# SAFFTY RECALL ACTION

Reference number:	RA-30-1471	Issued: 16 December, 2020	
Subject:	Headliner Foam Block Installation		
Model(s):	DBX		
VIN range:	Refer to the separately published list of affected Vehicle Identification Numbers (VINs)		
Applicable to:	USA & Canada		
Distribute to:	After Sales Manager W	/arranty Staff	
	Service Manager To	echnician(s)	
	Sales Manager Pa	arts Staff

# Reason for this Safety Recall Action (NHTSA Reference XXX-XXX)

Figure 3

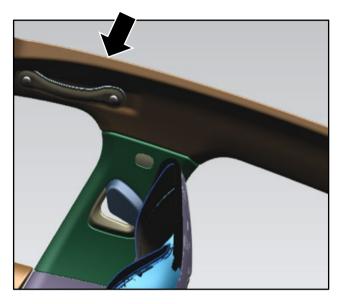
**1.** Find the headliner clipping point on the B pillar (refer to Figure 3).

Note: Access to the roof liner clipping point is the same on both sides of the vehicle.

Figure 6

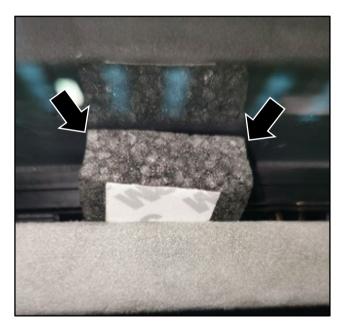
**4.** Put the headliner foam block into position between the roof rail and the headliner (refer to Figure 6).
